## HISTORIC AND DESIGN REVIEW COMMISSION

**HDRC CASE NO:** 2025-135  
**ADDRESS:** 240 E LULLWOOD AVE  
**LEGAL DESCRIPTION:** NCB 6727 BLK 3 LOT 21 AND 22  
**ZONING:** RM-4, H  
**CITY COUNCIL DIST.:** 1  
**DISTRICT:** Monte Vista Historic District  
**APPLICANT:** KRISTEN WEBER/Lullwood Studio  
**OWNER:** KRISTEN WEBER/WEBER KRISTEN L & DANIEL R STACY  
**TYPE OF WORK:** New construction of a 2-story rear accessory structure  
**APPLICATION RECEIVED:** May 15, 2025  
**60-DAY REVIEW:** July 14, 2025  
**CASE MANAGER:** Bryan Morales  
**REQUEST:**

The applicant is requesting a Certificate of Appropriateness for approval to construct an approximately 1,992 sf 2-story rear accessory structure.

### A3.1

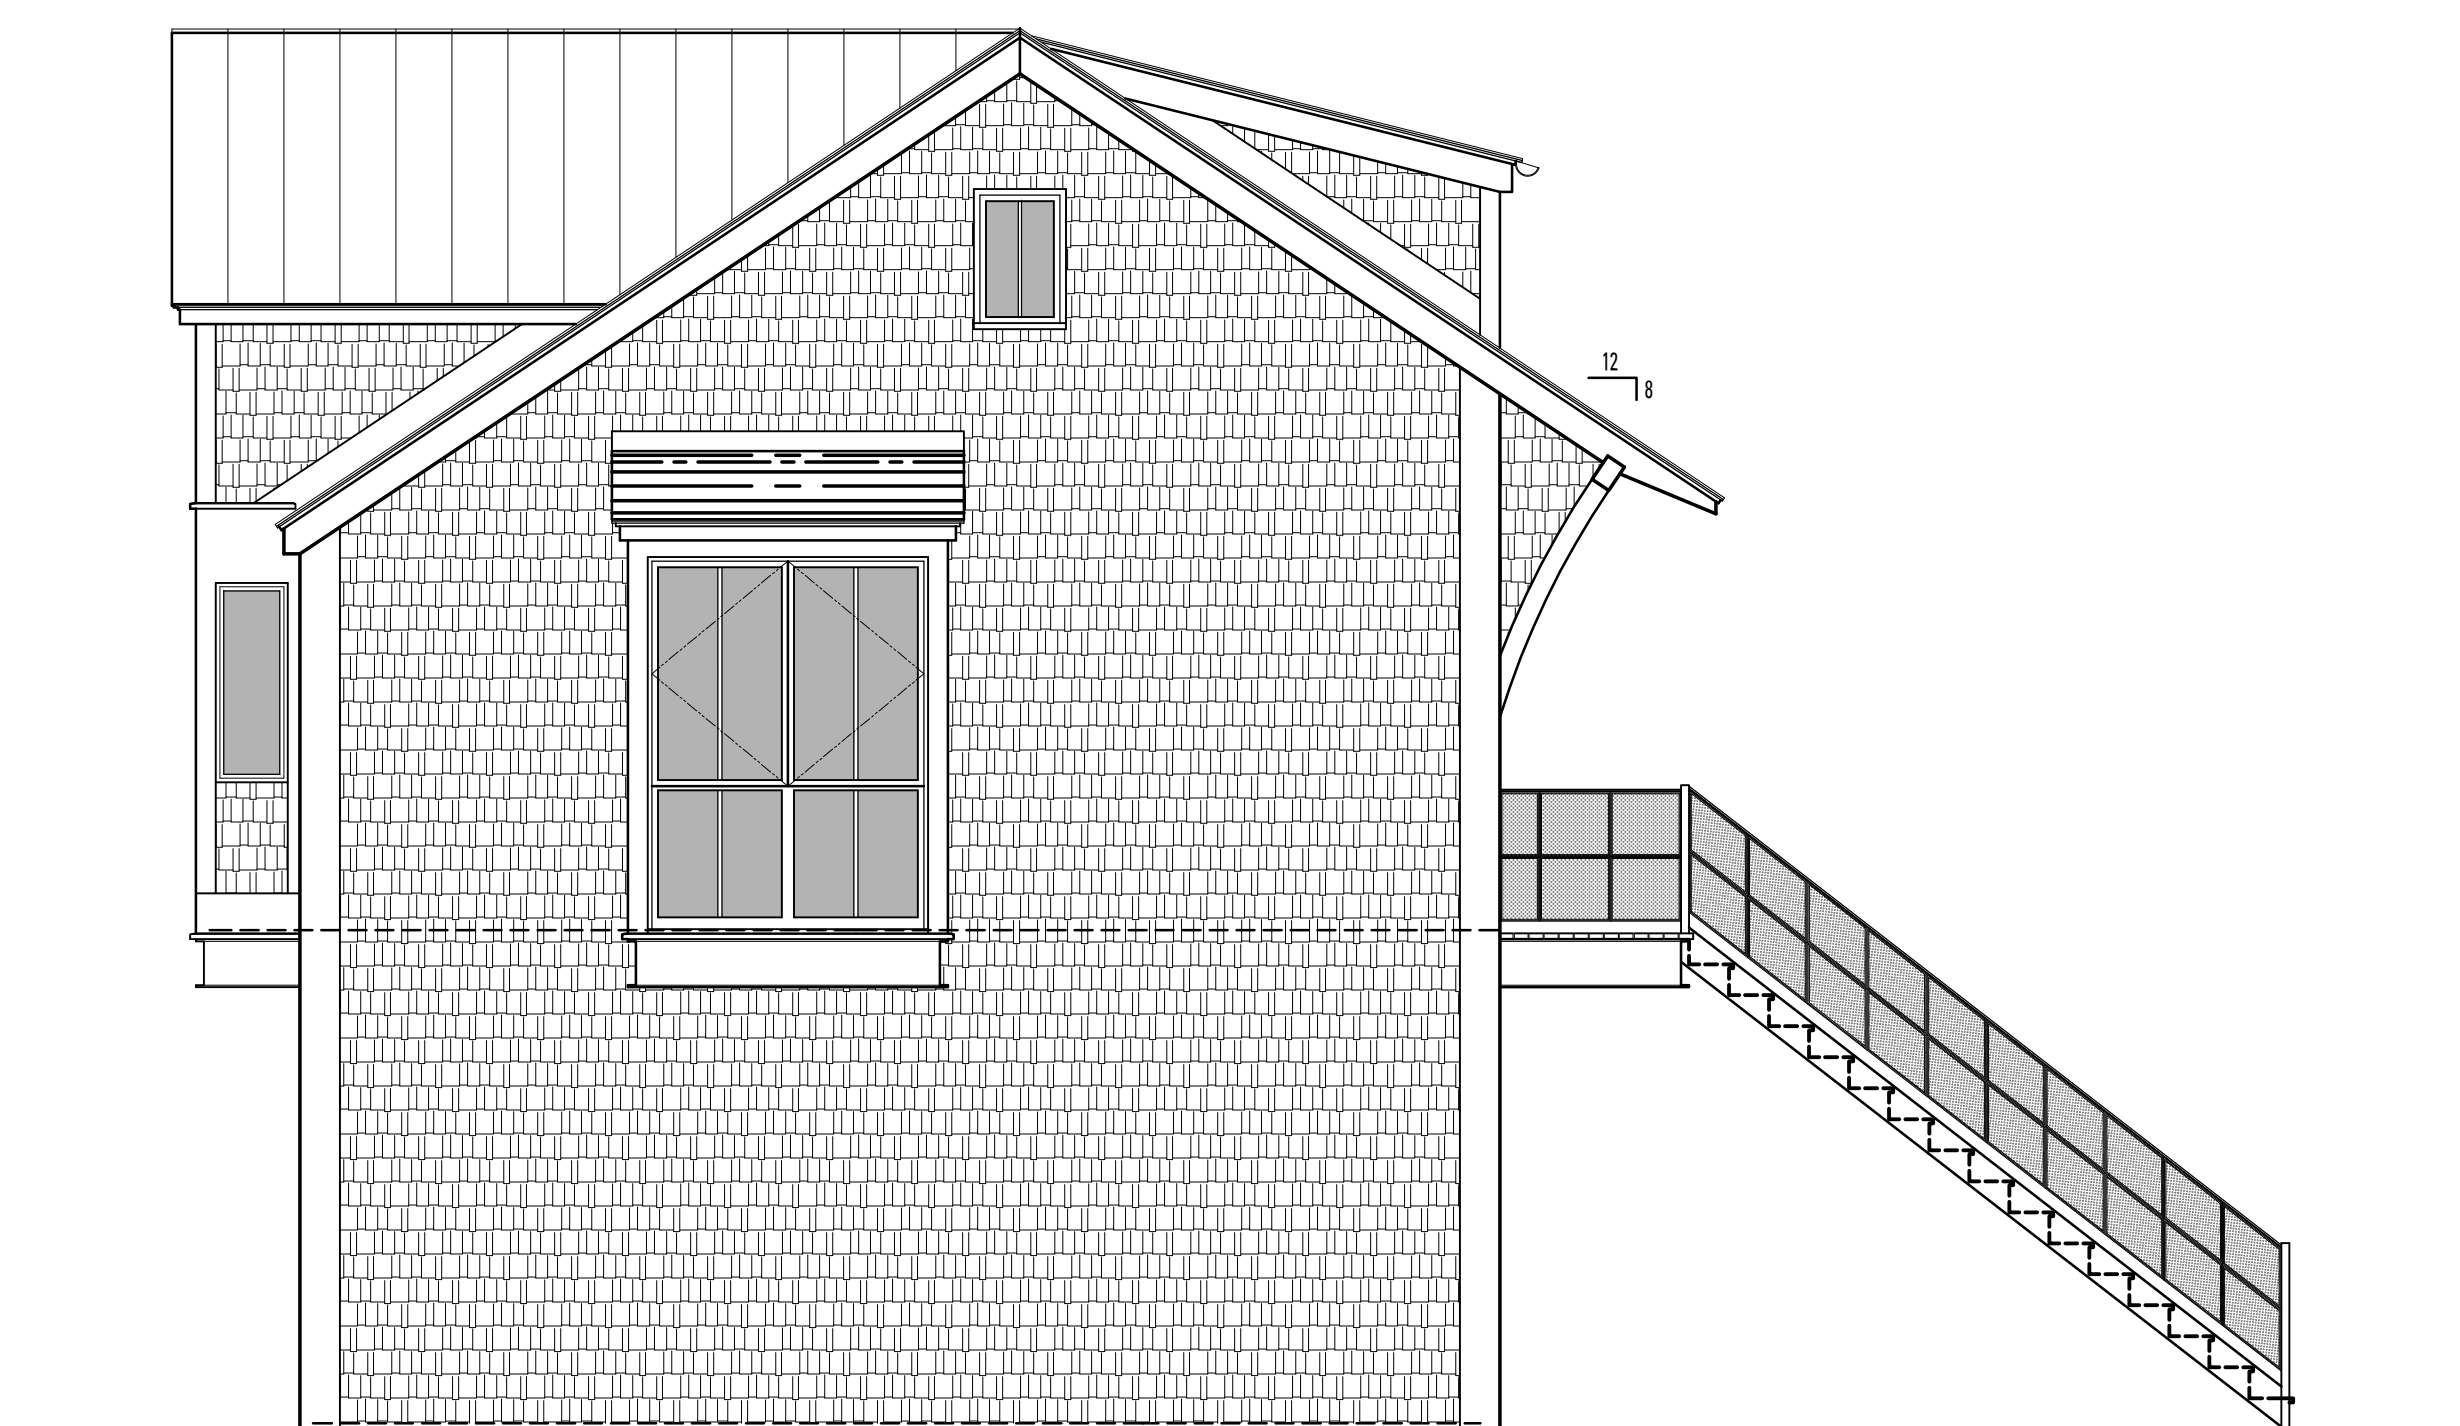
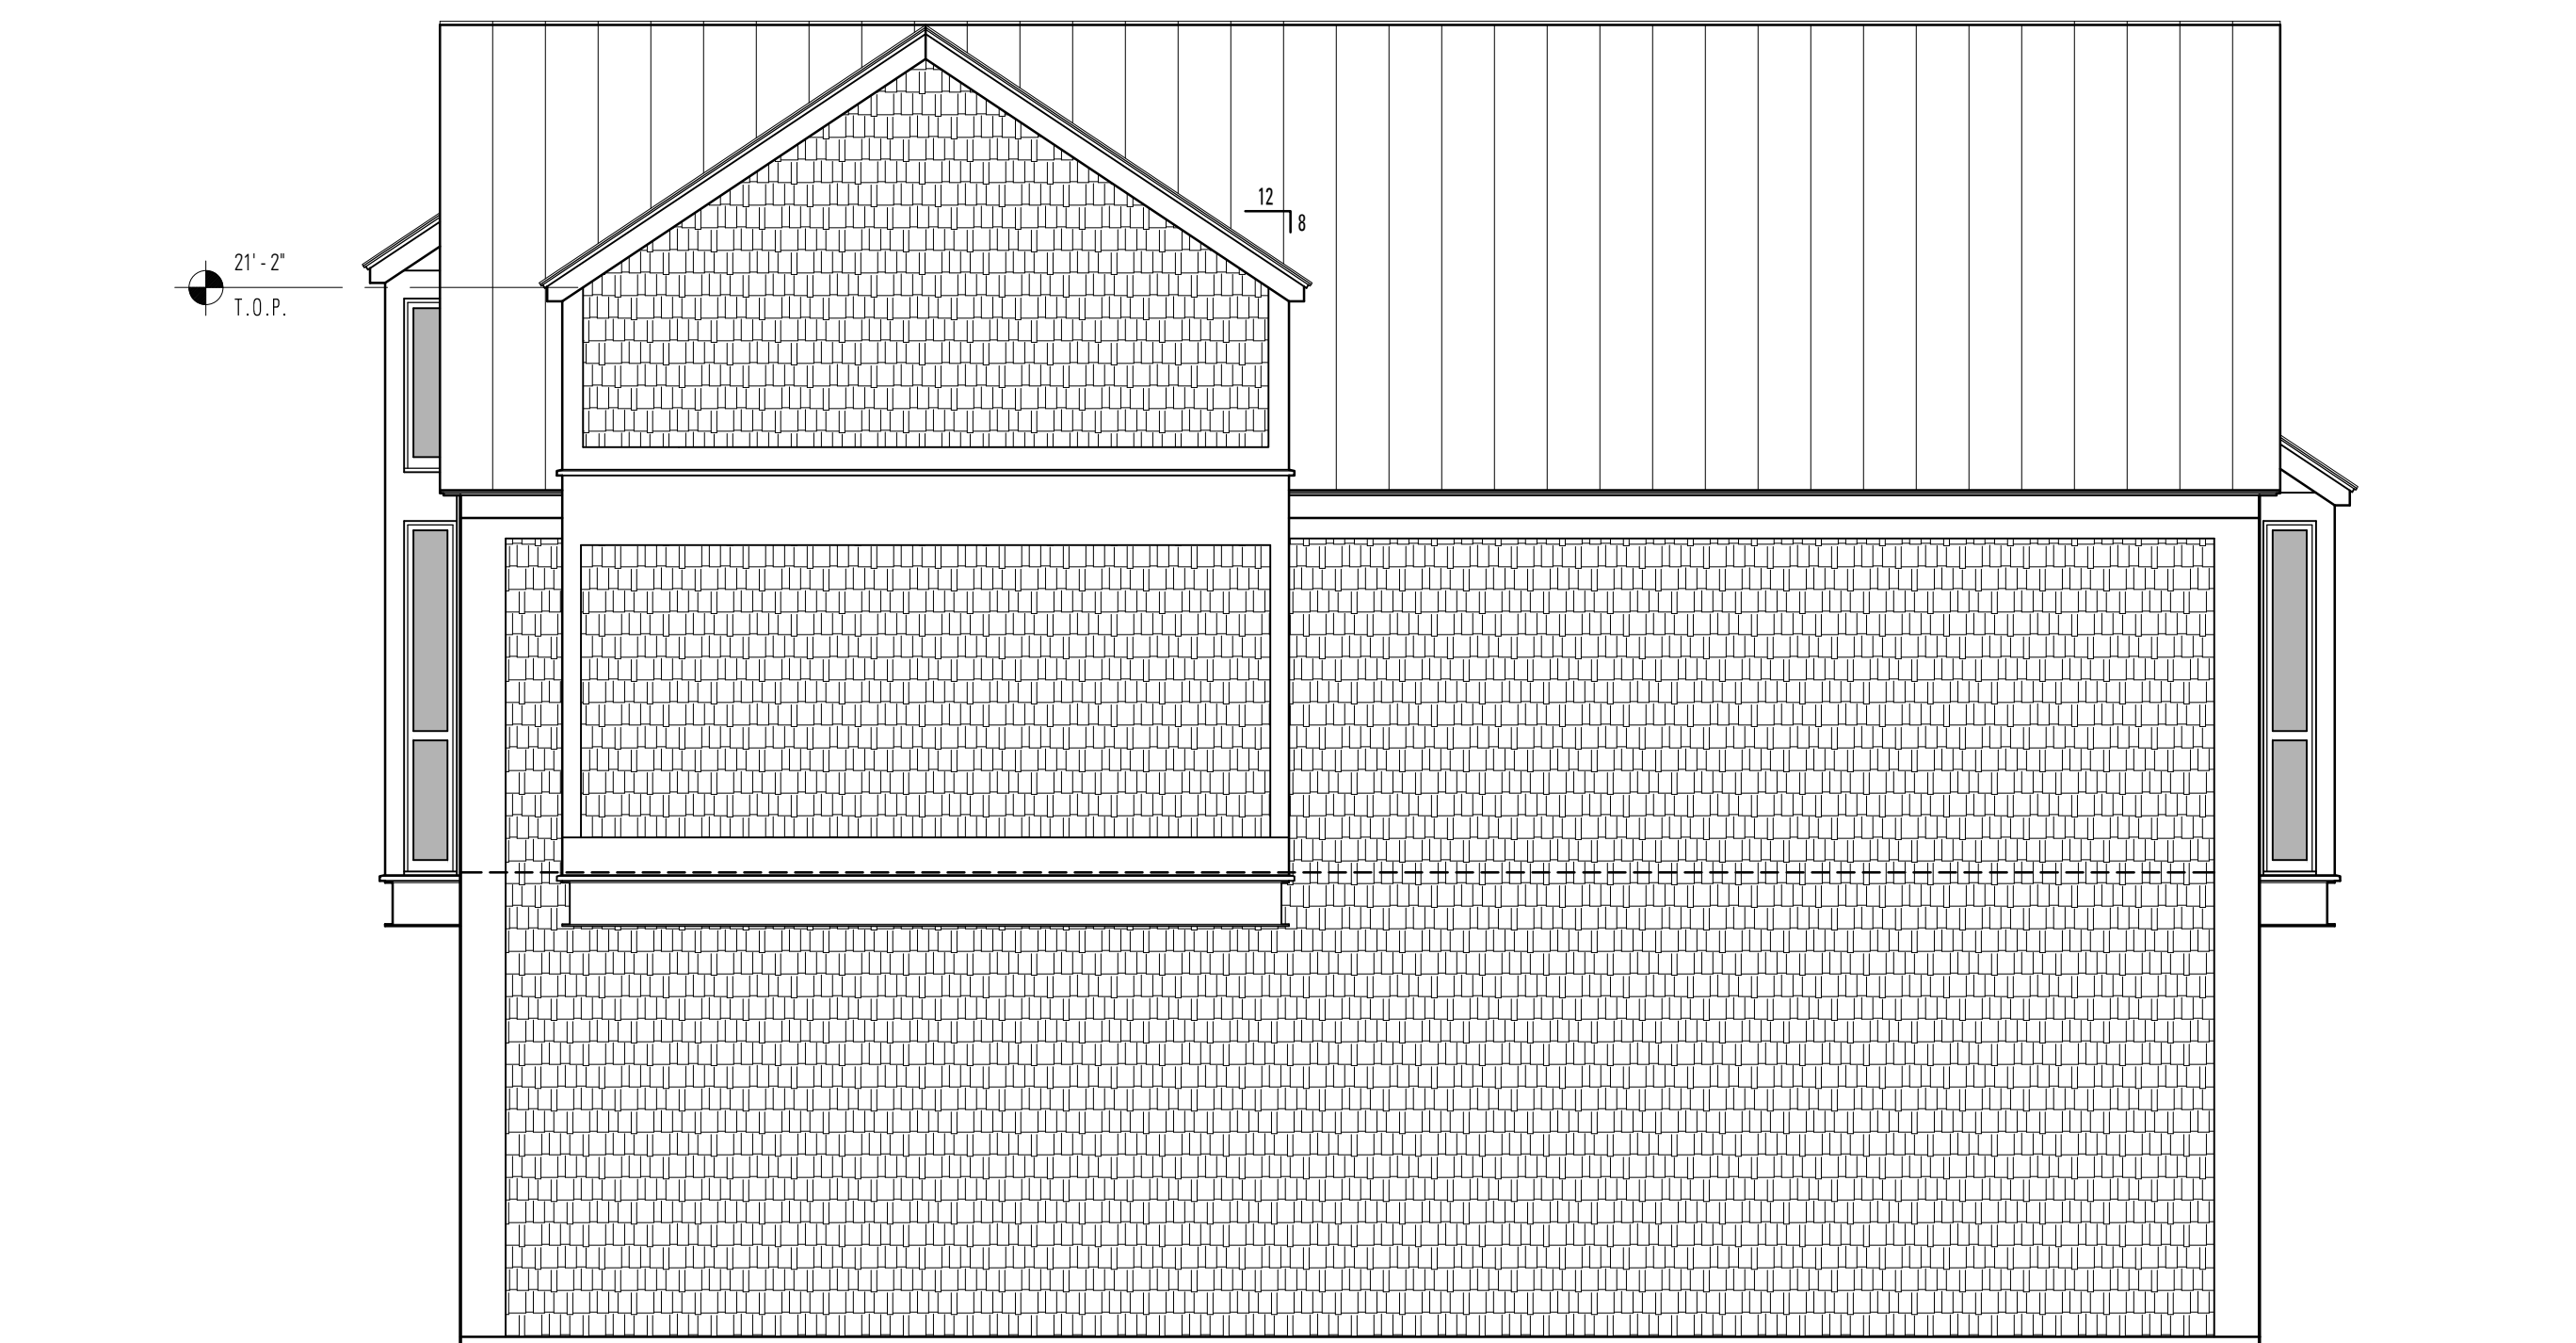
- f. ROOF FORM & MATERIAL – The applicant is requesting approval to construct a 2-story rear accessory structure with a garage featuring a side-facing standing seam metal gable roof, a north-facing dormer, and a south-facing gable. New Construction 5.A.iii. and 5.A.iv. note that new accessory structures should relate to the period of construction of the primary historic structure on the lot by using complementary materials and simplified architectural details. Staff finds the roof forms and material conforms to Guidelines.

- g. ARCHITECTURAL DETAILS – The applicant is requesting approval to construct a 2-story accessory structure at the rear of the property featuring a double-bay with two garage doors; two-over-two, one-over-one, and fixed windows; second-story balcony at the north façade; an oriel at the east façade; and an oriel at the west façade. The Guidelines for New Construction 5.A.iii. and 5.A.iv. note that new accessory structures should relate to the period of construction of the primary historic structure on the lot by using complementary materials and simplified architectural details. Staff finds the proposed architectural details generally appropriate.

- i. **ARCHITECTURAL DETAILS (FENESTRATION PATTERN)** – The applicant is requesting approval to install three single doors, three dormer windows, a fixed window, two one-over-one windows, two garage doors, and four two-over-two windows on the north façade; one fixed window, two two-over-two windows, and a gable window on the east façade; one fixed window and two one-over-one windows on the south façade; and five fixed windows and two two-over-two windows on the west façade. New Construction 2.C.i. related to window and door openings stipulates to incorporate window and door openings with a similar proportion of wall to window space as typical with nearby historic facades. Staff finds the proposed fenestration pattern generally appropriate.

- i. That the applicant installs a fully wood or aluminum-clad wood window that meet staff's standard window stipulations and submits updated specifications to staff for review and approval. The windows should feature an inset of two (2) inches within facades and should feature profiles that are found historically within the immediate vicinity. Meeting rails must be no taller than 1.25" and stiles no wider than 2.25". White manufacturer's color is not allowed, and color selection must be presented to staff. There should be a minimum of two inches in depth between the front face of the window trim and the front face of the top window sash. This must be accomplished by recessing the window sufficiently within the opening or with the installation of additional window trim to add thickness. Window trim must feature traditional dimensions and architecturally appropriate sill detail. Window track components must be painted to match the window trim or concealed by a wood window screen set within the opening.

- ii. That the applicant install a standing seam metal roof featuring panels that are 18 to 21 inches wide, seams that are 1 to 2 inches high, a crimped ridge seam, and match the current finish or a standard galvalume finish. Panels should be smooth without striation or corrugation. Ridges are to feature a double-munch or crimped ridge configuration; no vented ridge caps or end caps are allowed. All chimney, flue, and related existing roof details must be preserved. An inspection must be scheduled with OHP staff prior to the start of work to verify that the roofing material matches the approved specifications. No modifications to the roof pitch or roof form are requested or approved at this time.

- iii. That the applicant install a fully wood garage door or a garage door with a design that mimics wood construction and features a smooth finish without a faux wood grain texture. Final garage door specifications must be submitted to staff for review and approval prior to the issuance of a Certificate of Appropriateness.
